MEMORANDUM

RE: Response to Comments on NOI for DEP #CE 204-0991, The Reconstruction of Foster Street in Littleton, MA

RE: Stormwater Analysis
Reconstruction of Foster Street Project (MassDOT Project #609054)
MassDEP File #204-0991

15 MODIFIED ROCKFILL WITH COMPOST AND SEED COVER
SCALE: N.T.S.

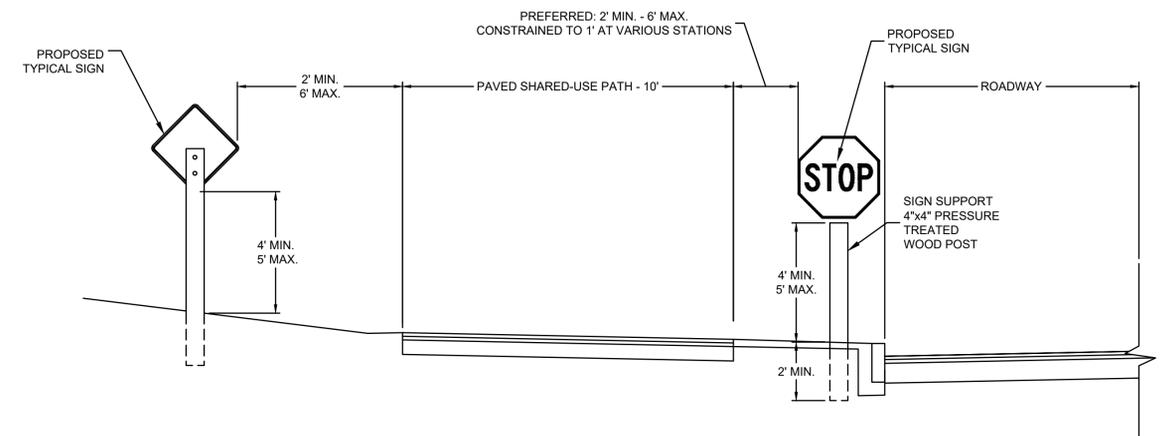
- Commissioners asked about vegetation on the side slopes. The slopes are proposed to be seeded with grass. No plants are currently proposed, but additional vegetation could be added to the project. Commissioners suggested that F&O consider more robust planting plans than grass.

The MassDOT specification for modified rockfill calls for the use of a geotextile fabric rated for slope stability, crushed stone, and boulders up to 8 inches in diameter. The modified rockfill slope will have a

compost surface treatment that will be seeded with a native seed mix called New England Roadside Wet Meadow Seed Mix. The specification for the native seed mix is included in Attachment 4. This native seed mix is better suited to grow on the compost fill in partial shade over the modified rockfill than plantings such as small shrubs.

LANDSCAPING PLANS

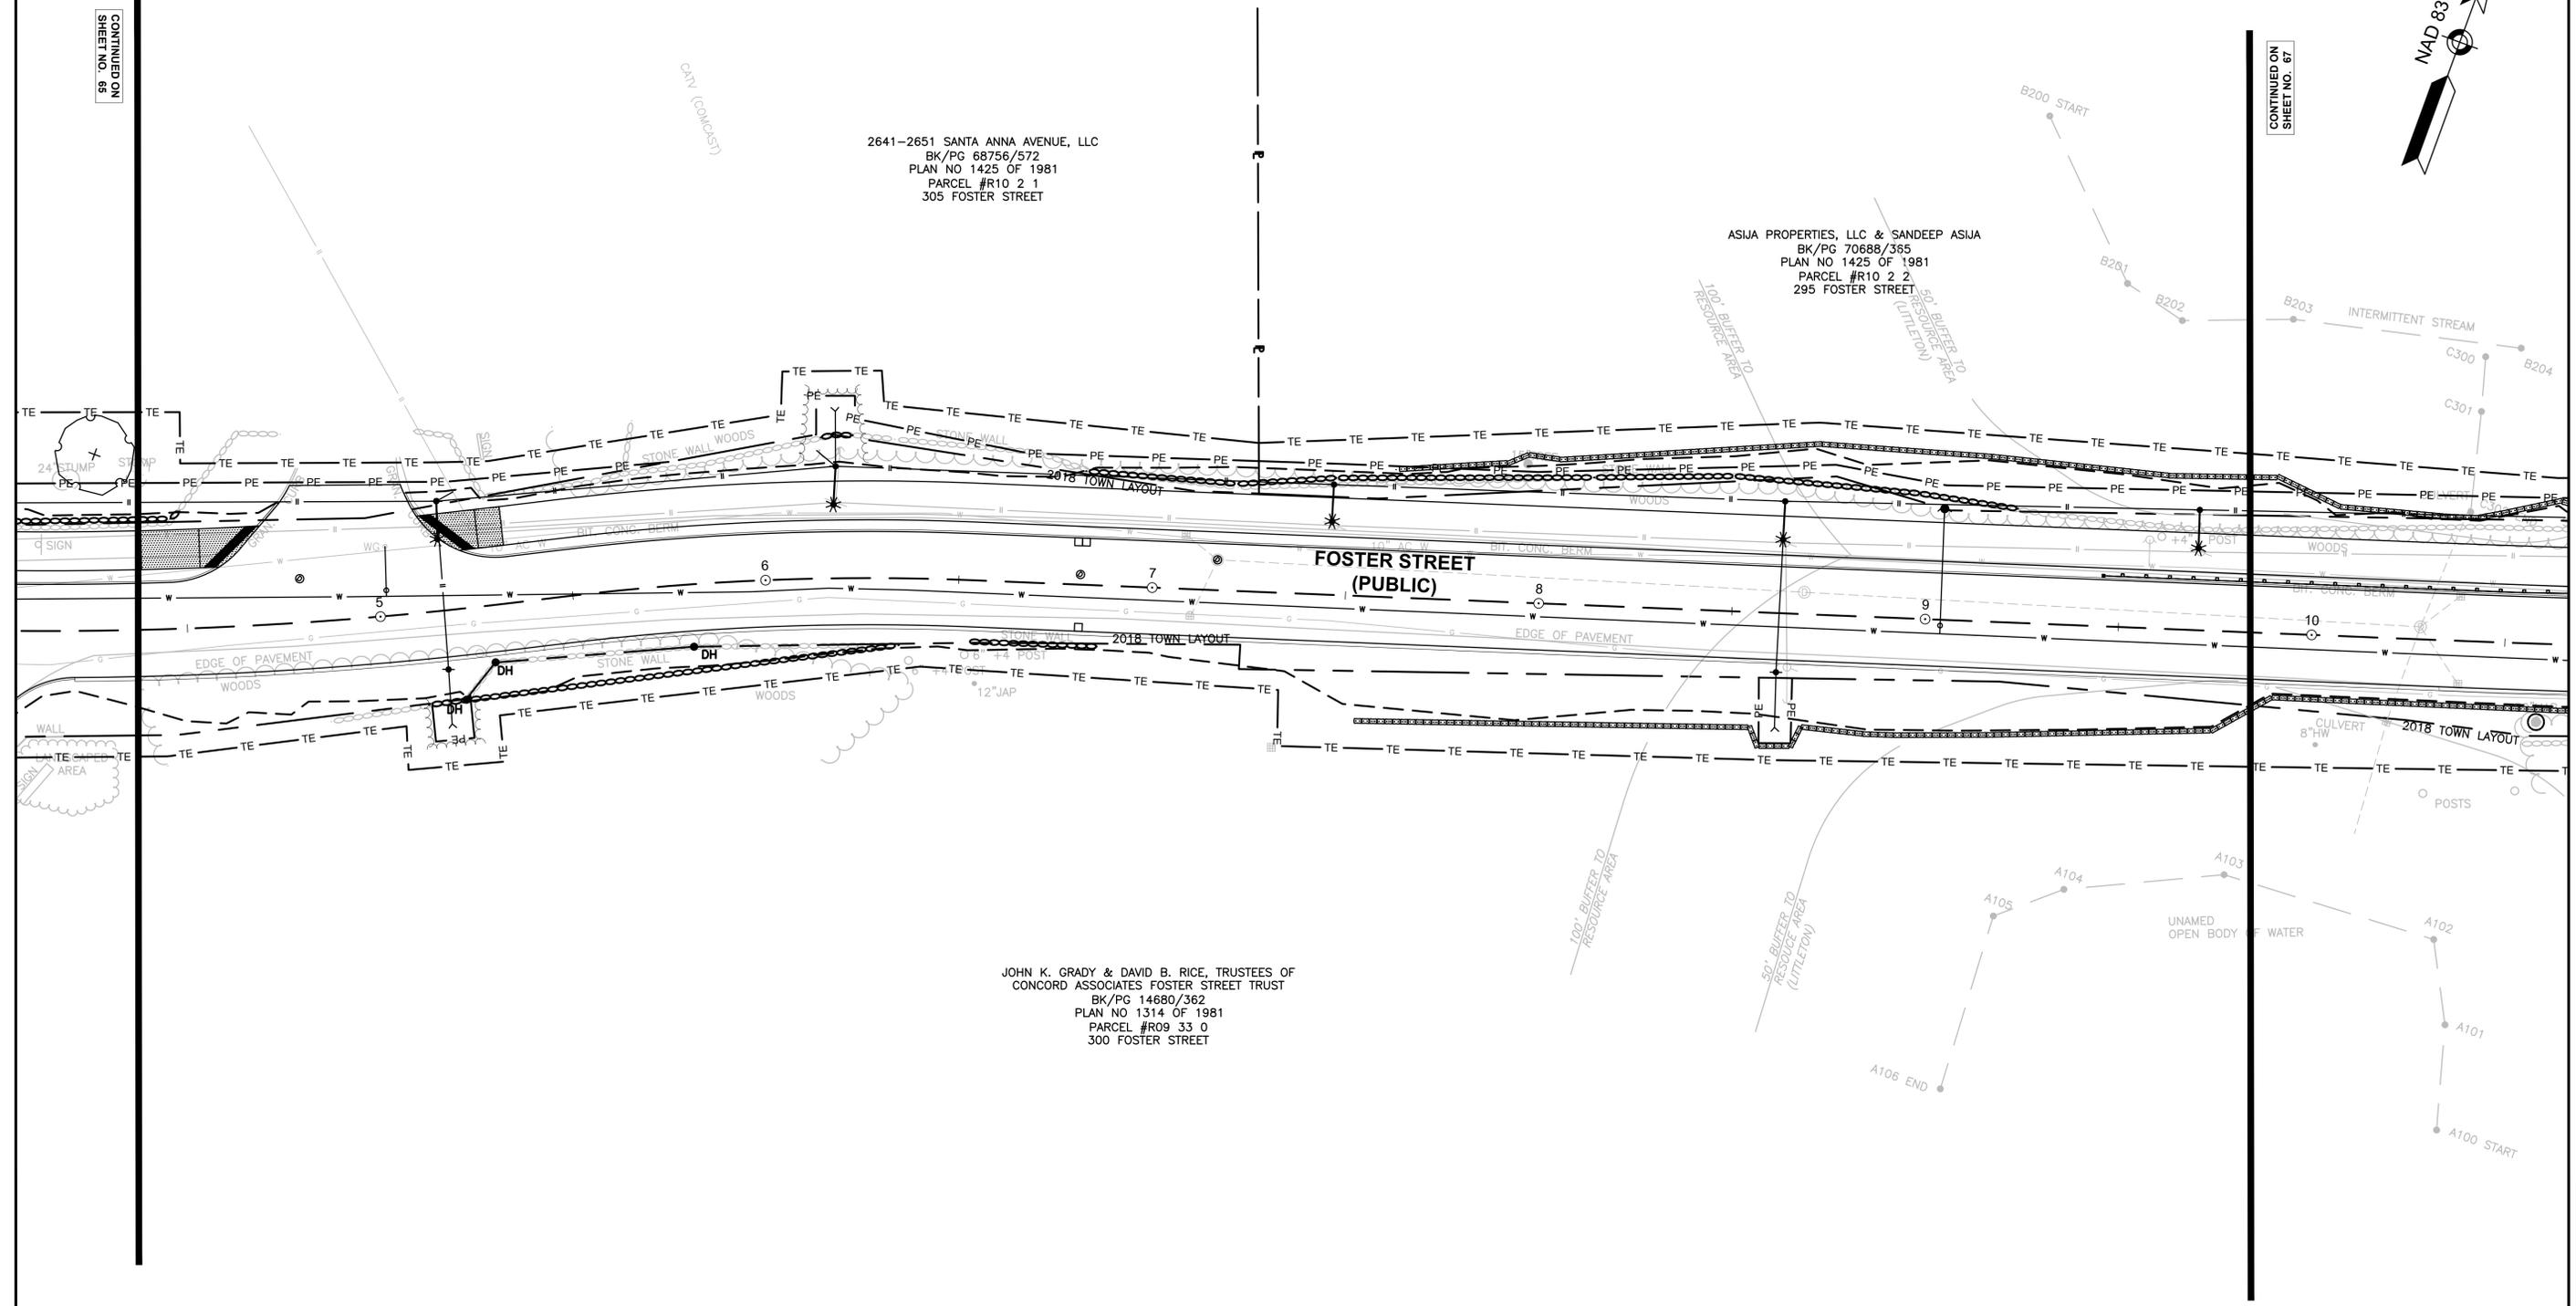
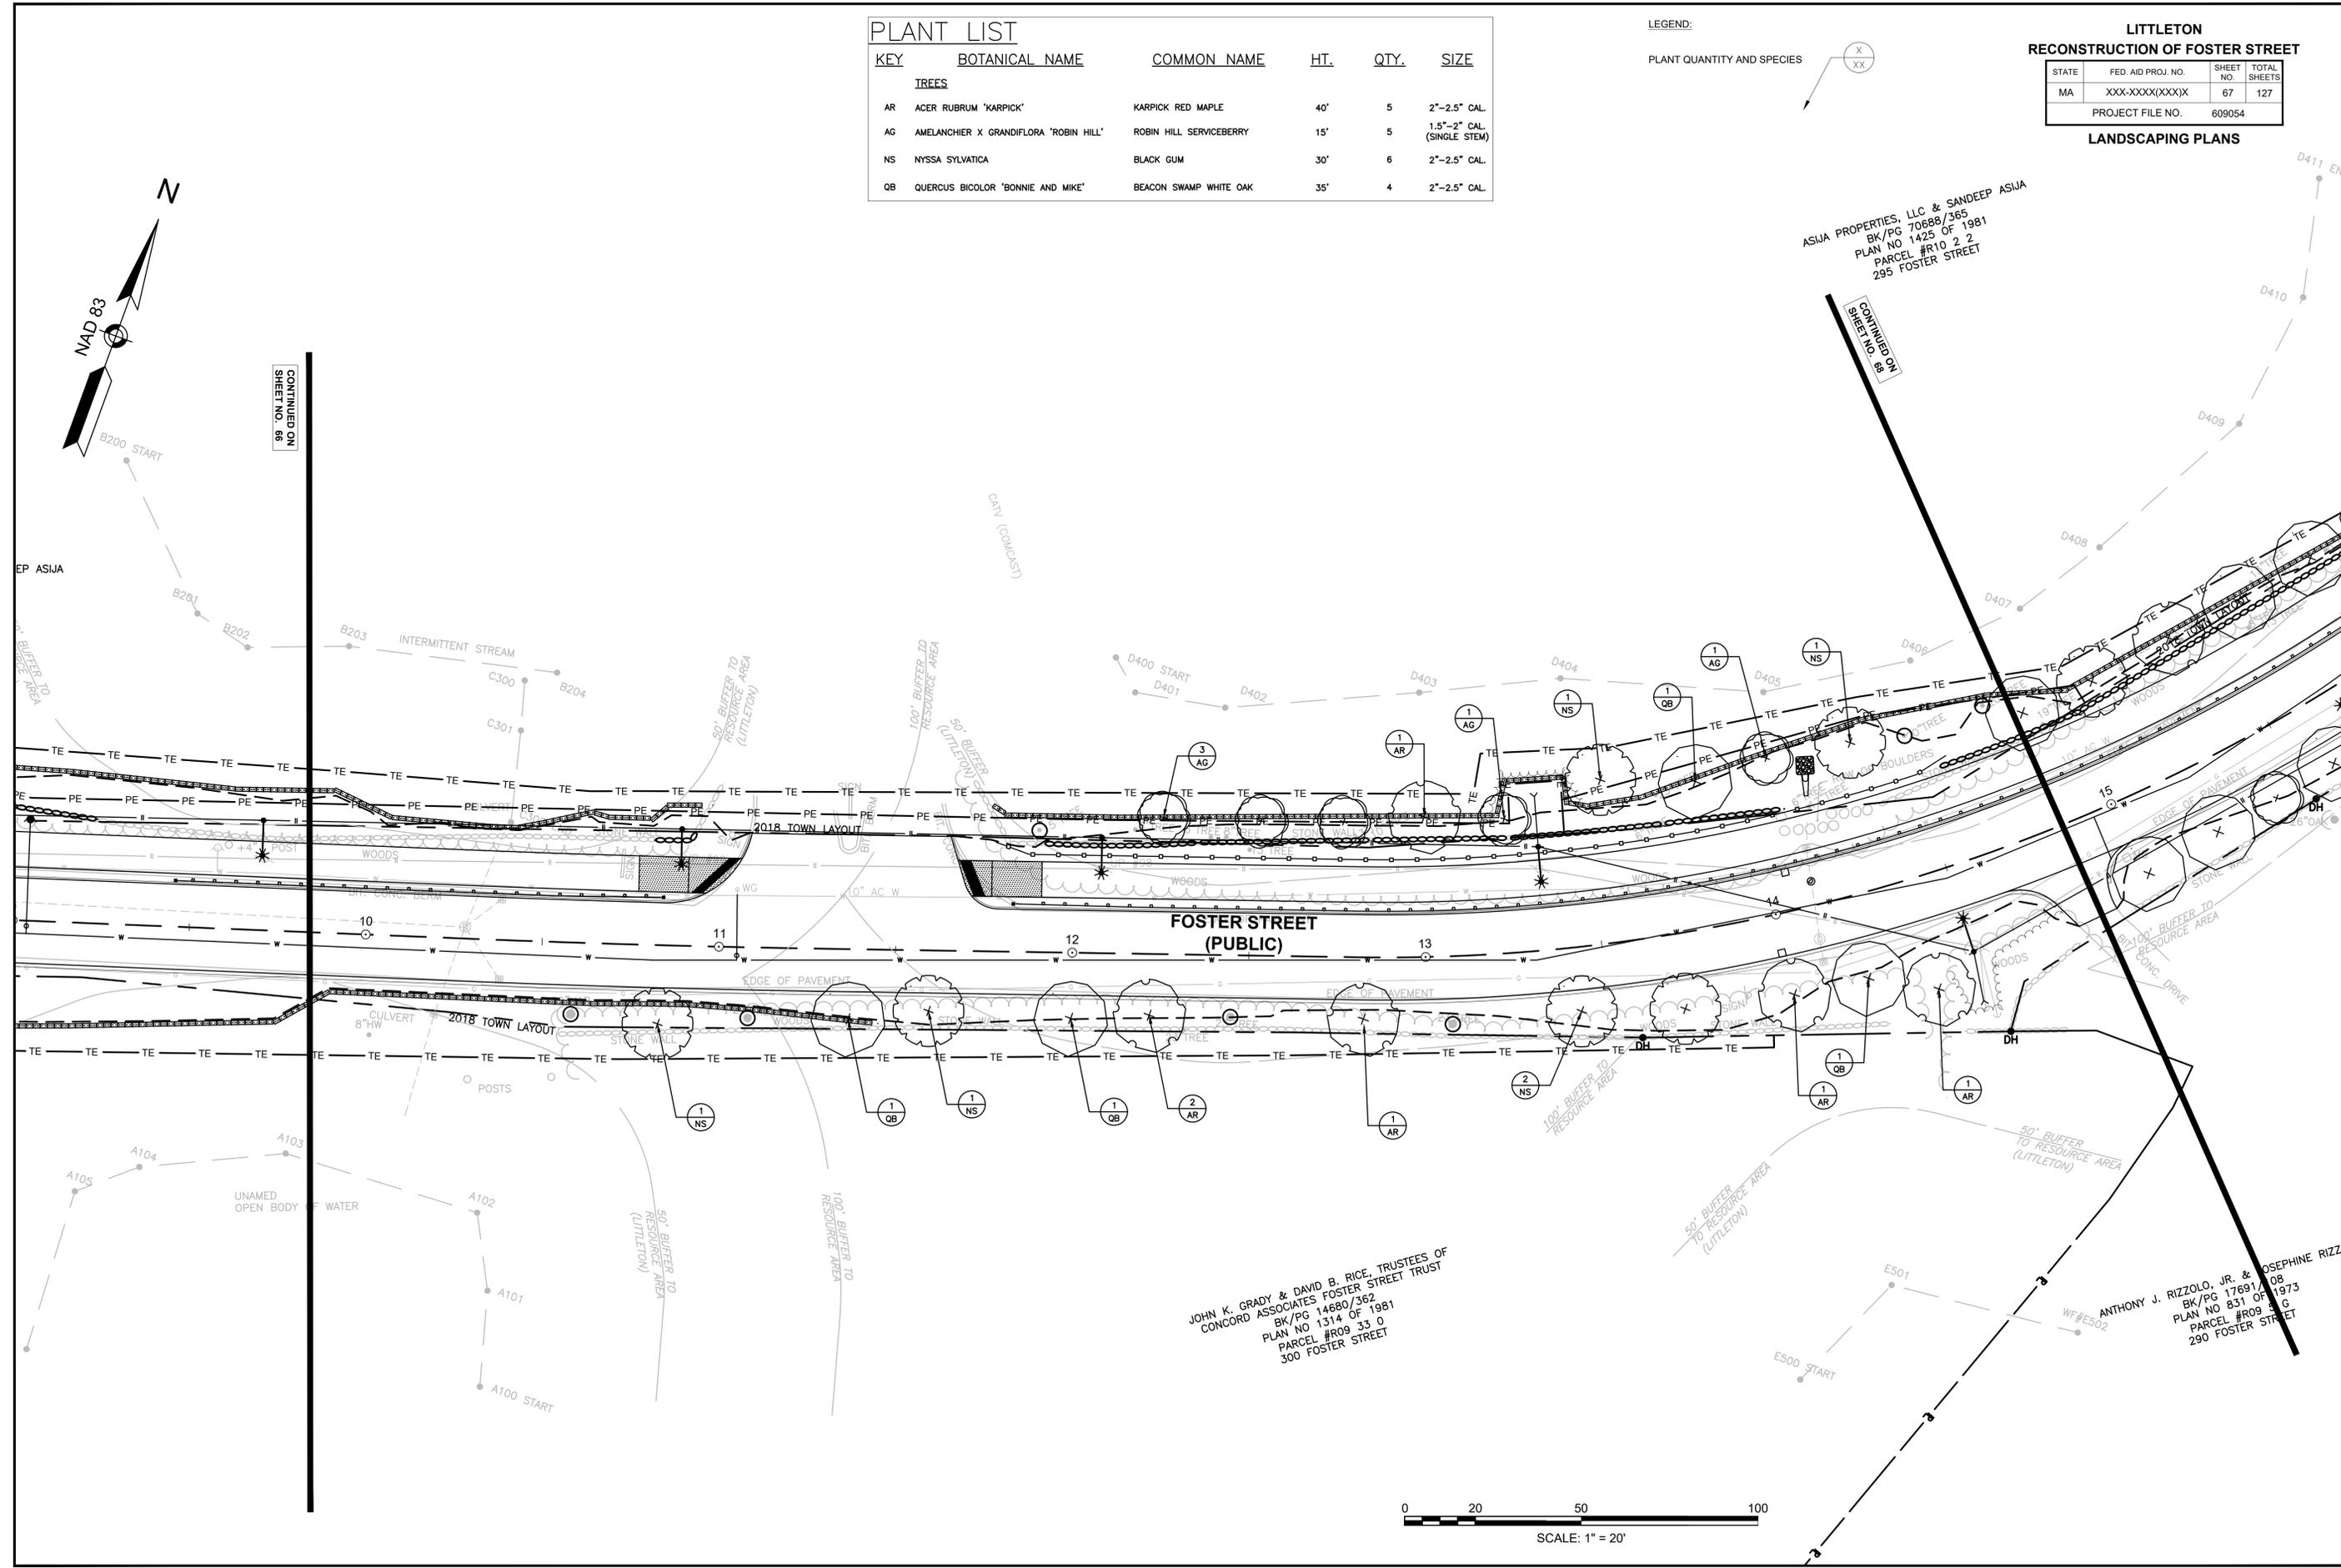
- Commissioners requested a tree inventory of trees to be taken at the 260 Foster St parcel including station, size, and species. A commissioner stated a replacement ratio of 2:1 was advised. Older and larger trees should be replaced at a higher ratio. Commissioners noted that trees likely to die as the result of the work (e.g., due to backfill around the tree base) need to be considered as tree removals.

F&O Response #6: F&O created a tree inventory in the 100-foot Buffer Zone listing trees that will be impacted from slope construction. The inventory lists proposed replacement tree quantities and species and is included in Attachment 5. The proposed tree replacement ratio is 2:1. The replacement trees were selected from the Town of Littleton Tree Guidelines document. New planting plan sheets showing the location of proposed tree replacements are also included in Attachment 5.
